From: Ron Wolanski, Town Planner

Re: **Public Hearing** - Application of A1 Roofing & Construction, LLC for Development Plan Review for renovation of an existing commercial building including exterior changes and requests for waivers from certain provisions of the commercial development design requirements of Section 521 of the Middletown Rules and Regulations Regarding the Subdivision and Development of Land. Property located at 1133 West Main Rd., Tax Assessors Plat 106, Lot 111.

Notice of Planning Board Decision

Re: Application of A1 Roofing & Construction LLC for Development Plan Review for renovation of an existing commercial building including exterior changes and requests for waivers from certain provisions of the commercial development design requirements of Section 521 of the Middletown Rules and Regulations Regarding the Subdivision and Development of Land. Property located at 1133 West Main Rd., Tax Assessors Plat 106, Lot 111

TITLE: ROOF PLAN

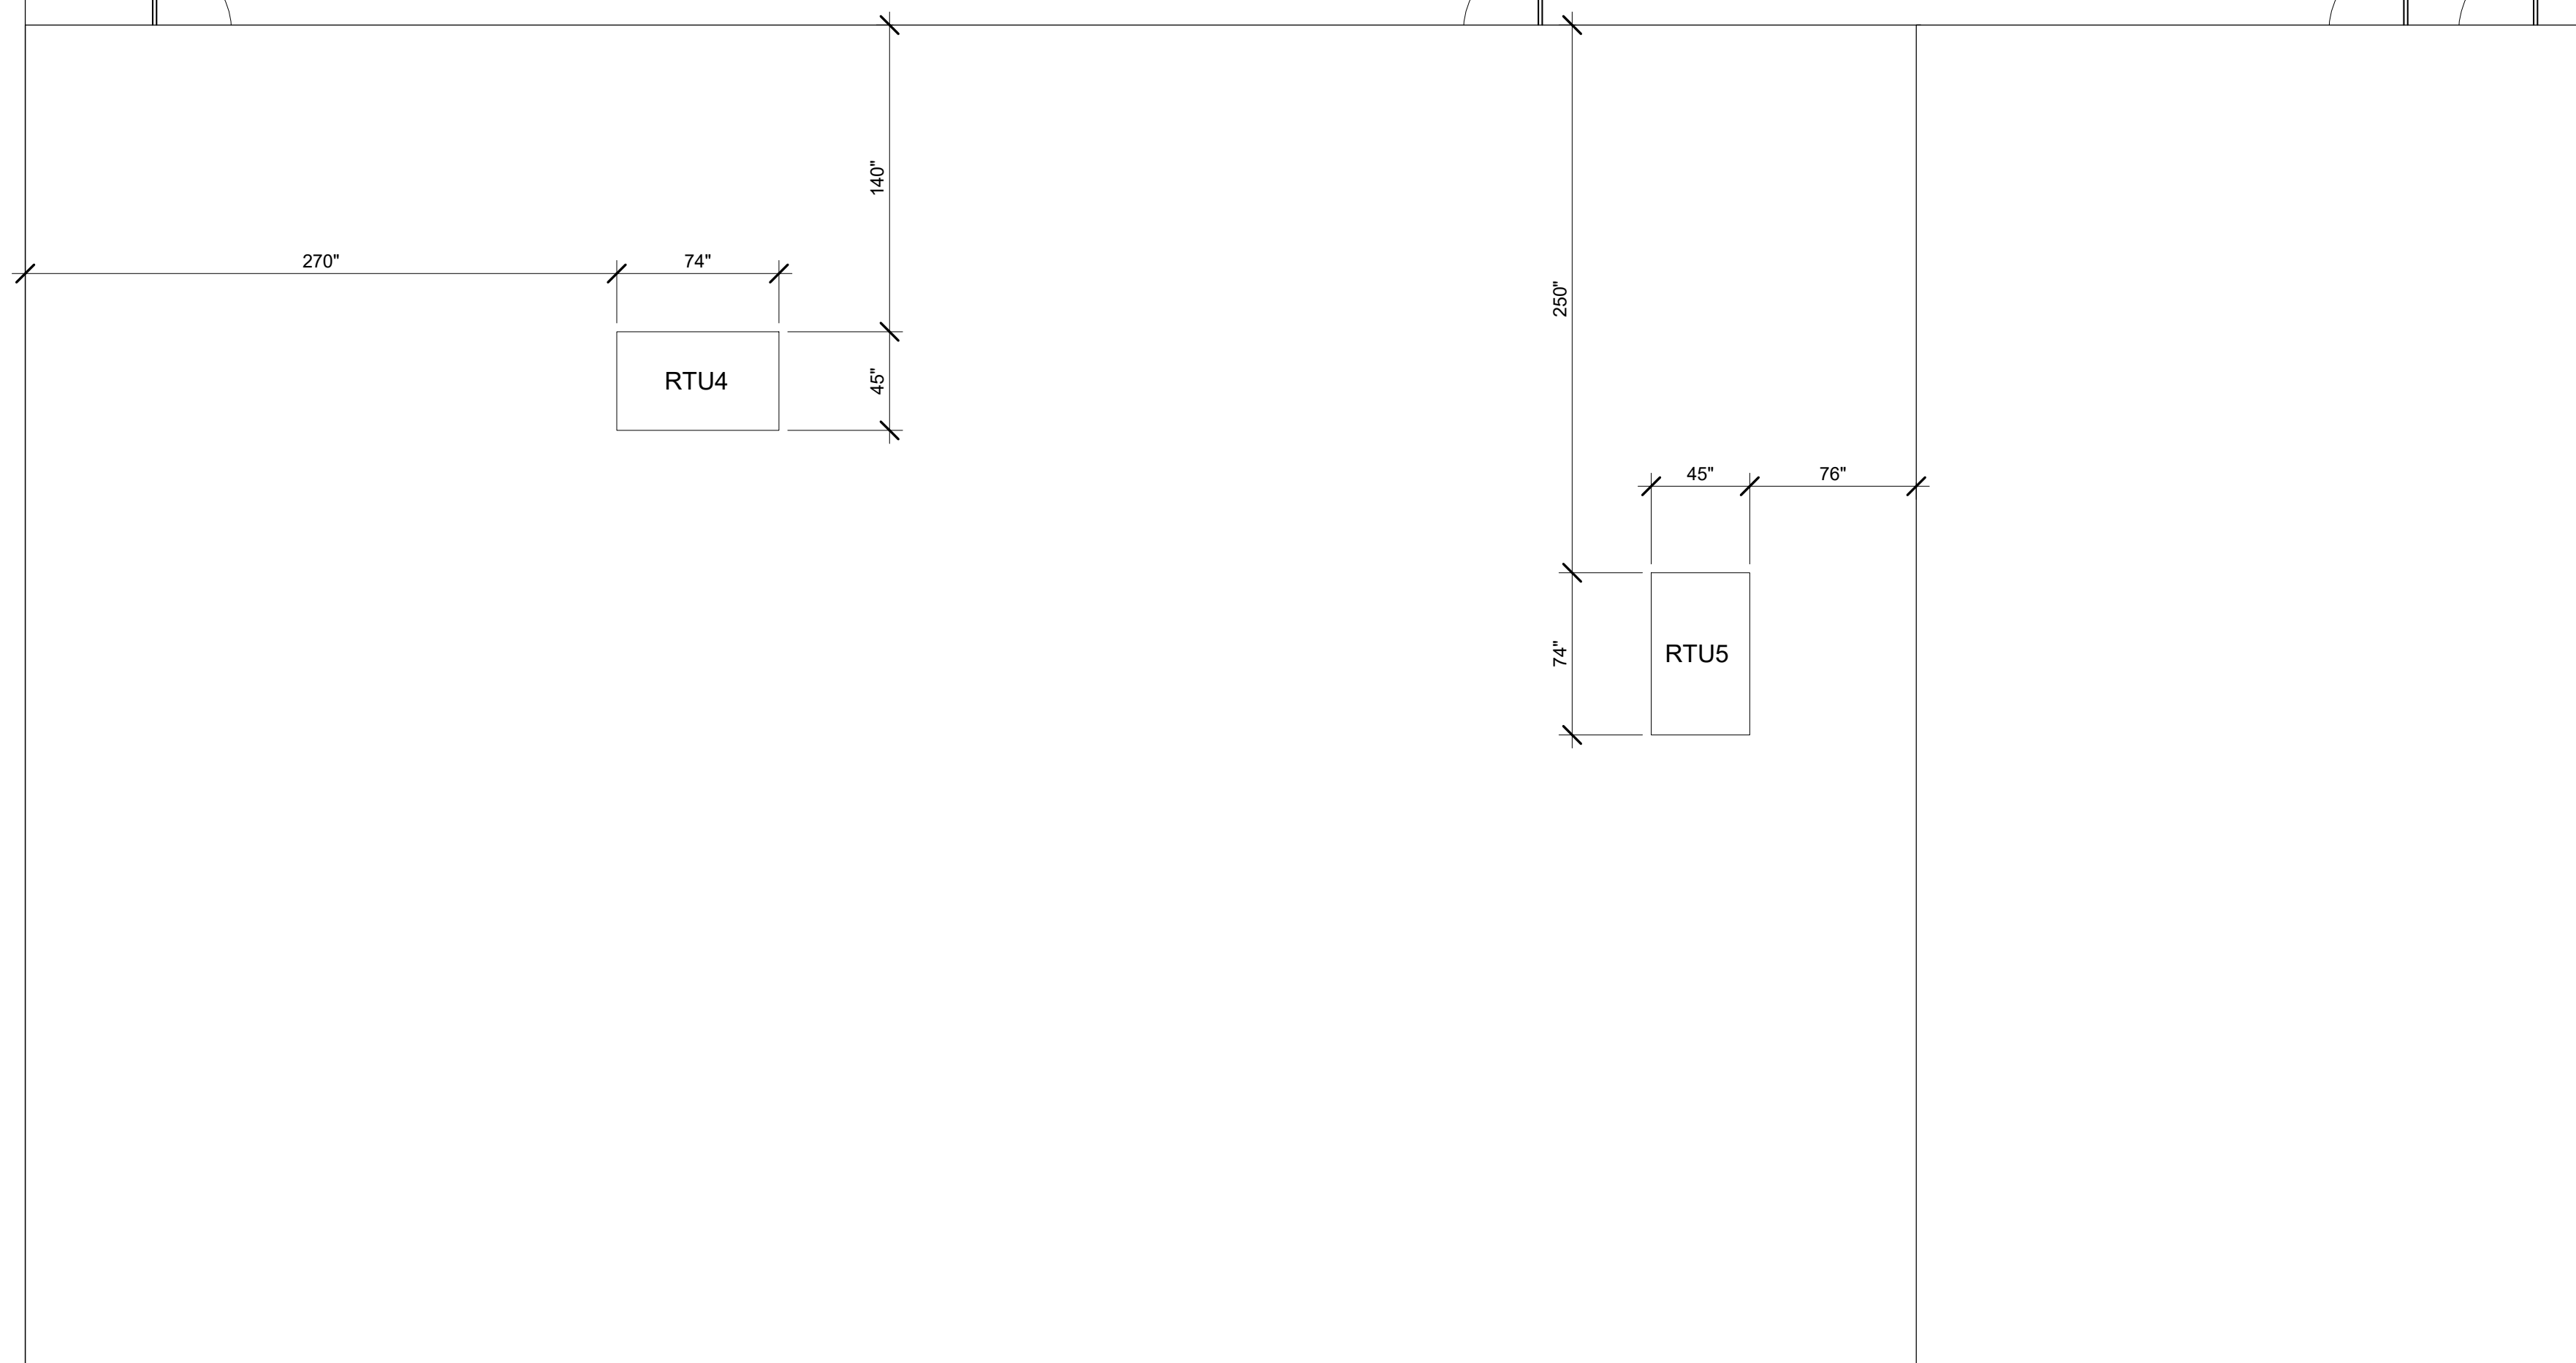
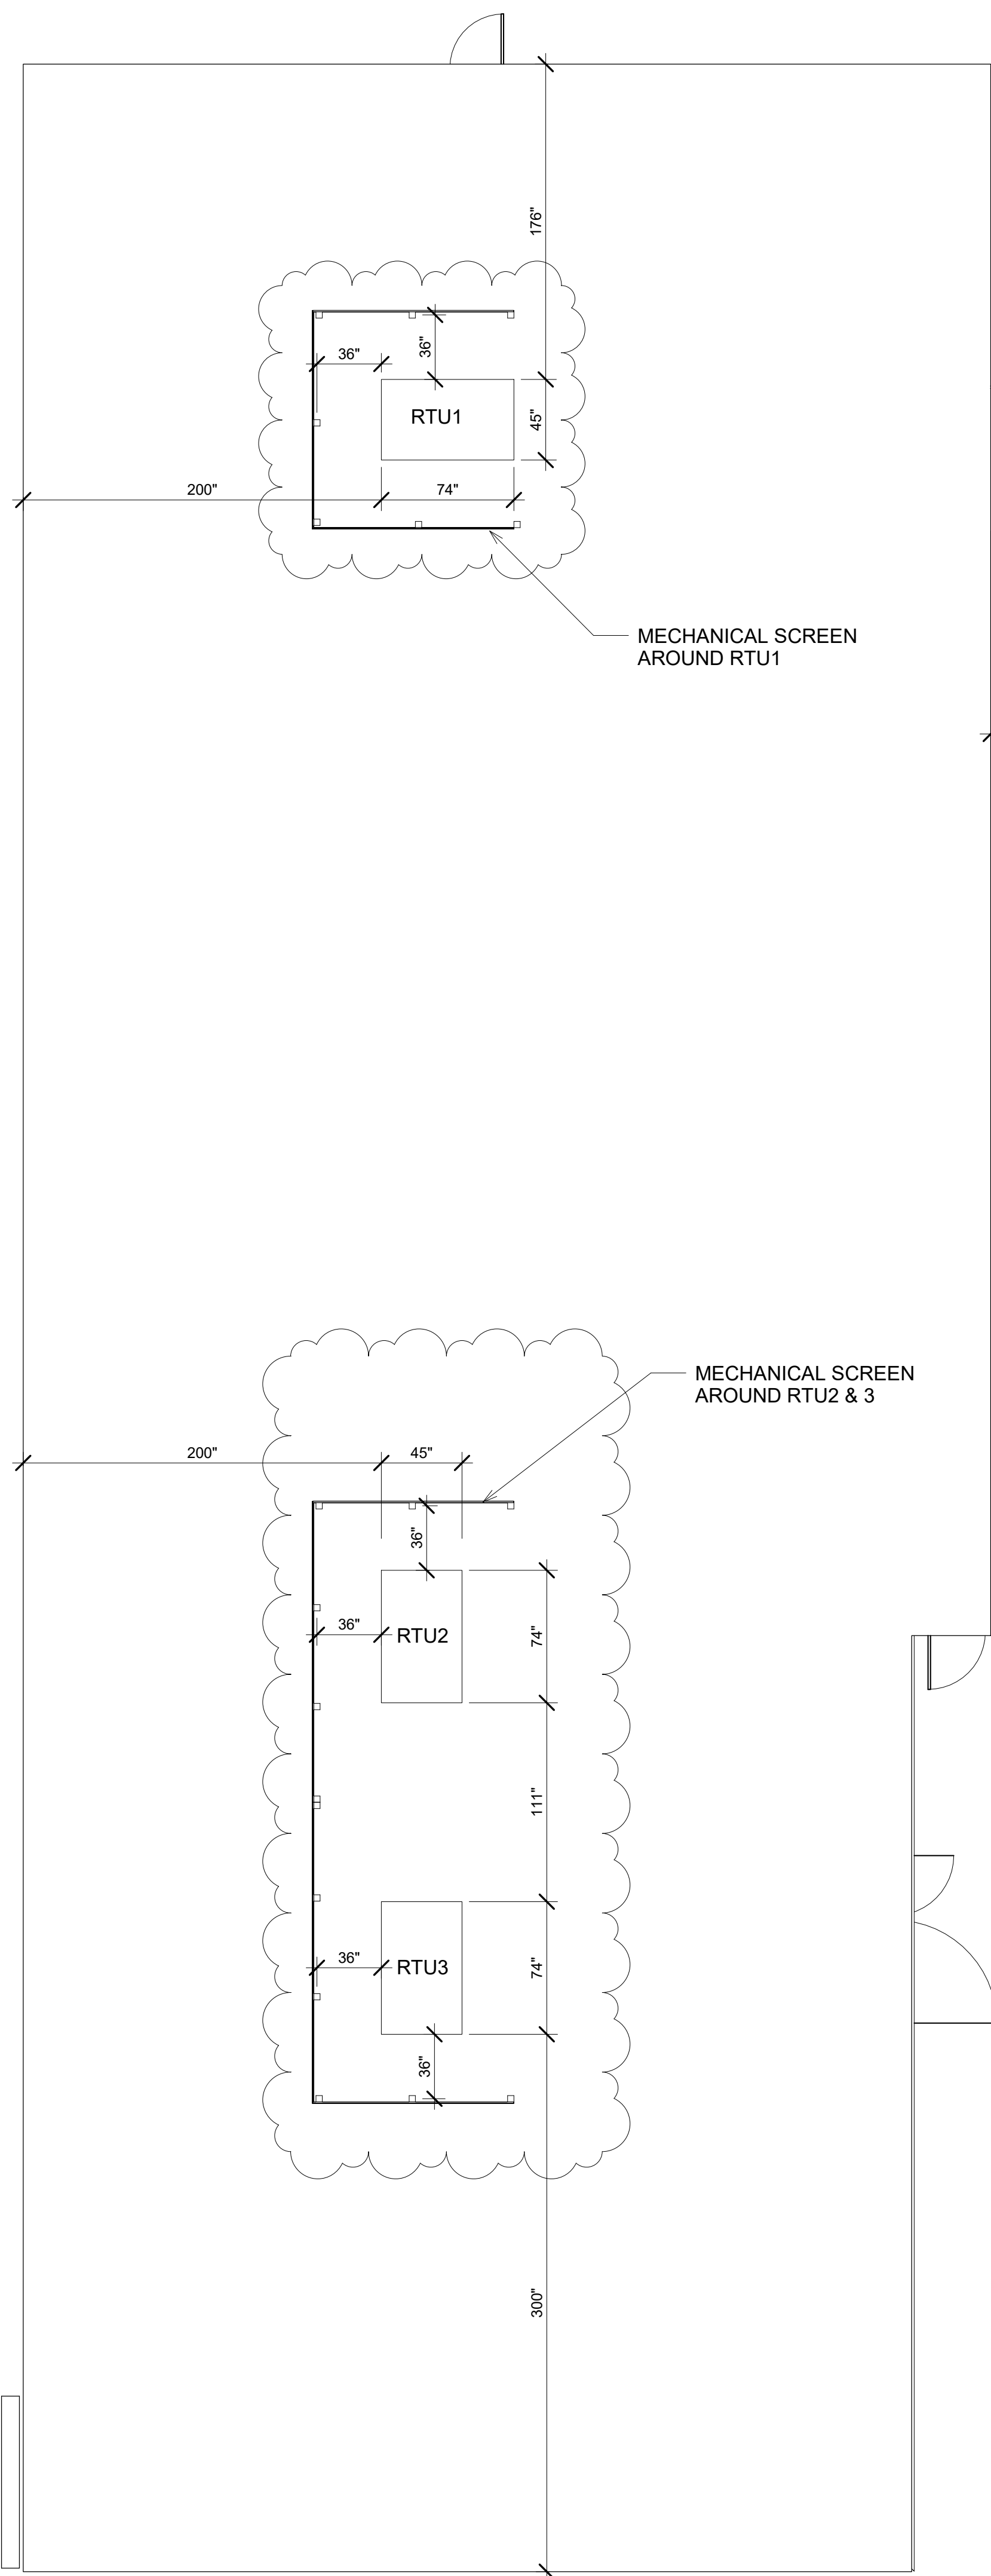
A question was asked during the October 11th meeting about the types of rooftop equipment that must be screened. Zoning Ordinance section 306(C) reads as follows:

While the ordinance cites HVAC equipment, it does not limit the types of rooftop equipment that must be screened. However, regarding possible need to screen rooftop solar panels, such a requirement might not be necessary or practical. For example, it would not be possible to screen panels on a sloped roof. If such a requirement were to be enforced, it would likely preclude use of solar panels on any sloped roof (commercial or multi-family buildings) visible from a public street. I don't believe that was the intent when the requirement was adopted. Also mentioned during the meeting, there are currently several examples in town of flat-roofed buildings with solar panels installed, including BJ's, Embrace Home Loans, West House, and the strip mall at the corner of East Main & Valley. These panels are not highly visible, if at all from the street due to their low profile. Screening would likely not be necessary for similar future installations.

During its meeting of October 11, 2023, the Planning Board held a public hearing regarding the above referenced application. At the conclusion of the discussion a motion was made and duly seconded and voted 6-0-0 to approve the application as presented, subject to the condition that the applicant return to the Planning Board for review and approval of the design for screening the rooftop equipment in accordance with Zoning Ordinance section 306(C). The public hearing remains open, and the matter was continued to the November 8, 2023 regular Planning Board meeting for the sole purpose of review of proposed rooftop screening. The plans subject to this decision include the following:
